Regulation No. 117 (Tyres rolling noise and wet grip adhesion)Proposal for amendments to ECE/TRANS/WP.29/GRB/2010/3

This document supersedes informal document No GRRF-67-16 transmitted by France and presented at GRRF of February 2010. The text reproduced below was prepared by the expert from France to introduce some corrections in the document ECE/TRANS/WP.29/GRB/2010/3 and to adjust some values remained between brackets. An explanation of the choice of these new values is provided in the appendix. It also includes additional results from experimental values to illustrate the influence of the tyre type number to be used for the alignment process. The modifications to the document ECE/TRANS/WP.29/GRB/2010/3 are marked in bold or strikethrough characters and supersedes GRRF-67-16.

Figure 1

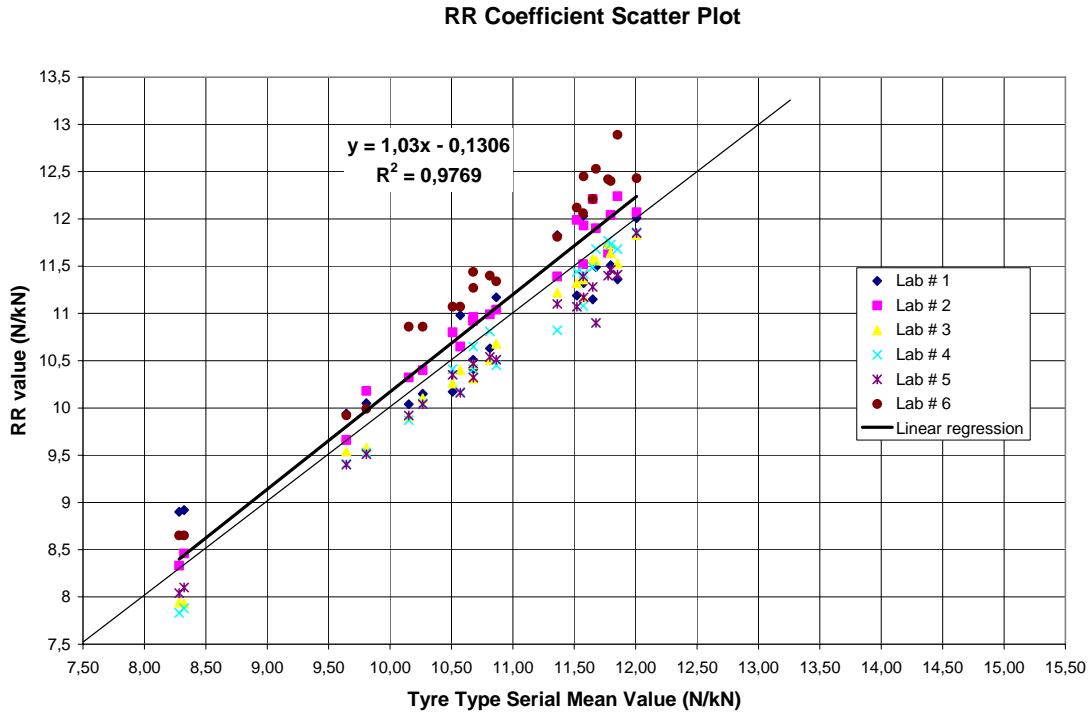
An example based on experimental measurement values obtained for 11 different tyre types in six different labs, is given hereafter, at figure 1. Two measurements were performed for each tyre in each lab. RR measured coefficients are plotted versus the calculated average of the RR obtained for the six labs, for each tyre type.

Figure 2

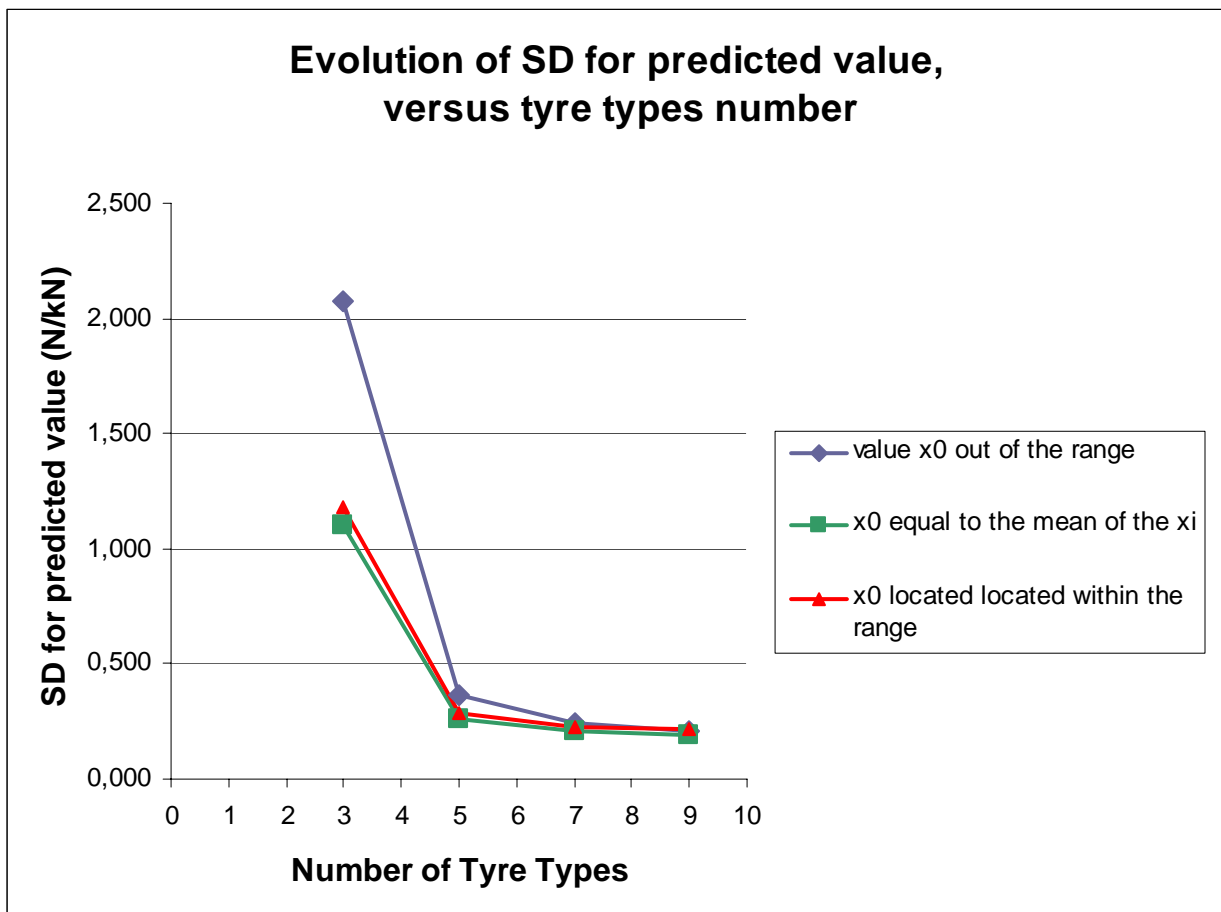
The evolution of standard deviation (SD) for the predicted value versus tyre types number is plotted in figure 2.

The standard deviation according to paragraph 5.3 of annex 9 is fixed to 0,075 N/kN.

A range of tyre type in between : 8,30 and 10,21 for 3 tyre types; 8,30 and 10,72 for 5 tyre types; 8,30 and 11,47 for 7 tyre types; 8,30 and 11,59 for 9 tyre types were considered.

- 1) predicted value is performed from a given value  $x_0 = 12 \text{ N/kN}$  located out of the range;
- 2) predicted value is performed from a given value  $x_0$  equal to the mean of the  $x_i$
- 3) predicted value is performed from a given value  $x_0 = 9 \text{ N/kN}$  located within range

These results confirm that the SD for predicted values decreases with the number of tyre types, whatever the case. It also confirms the need to measure at least more than five tyre types to obtain a good SD for predicted value. The worst case, in this example, is obtained when the SD for predicted value is evaluated, for a given value  $x_0$  located out of the range, especially for a reduced number of tyres. The SD for predicted value evaluated for a given value  $x_0$ , equal to the mean of the  $x_i$  or located within the range, is lower. Therefore, more than 5 tyre types are still necessary.
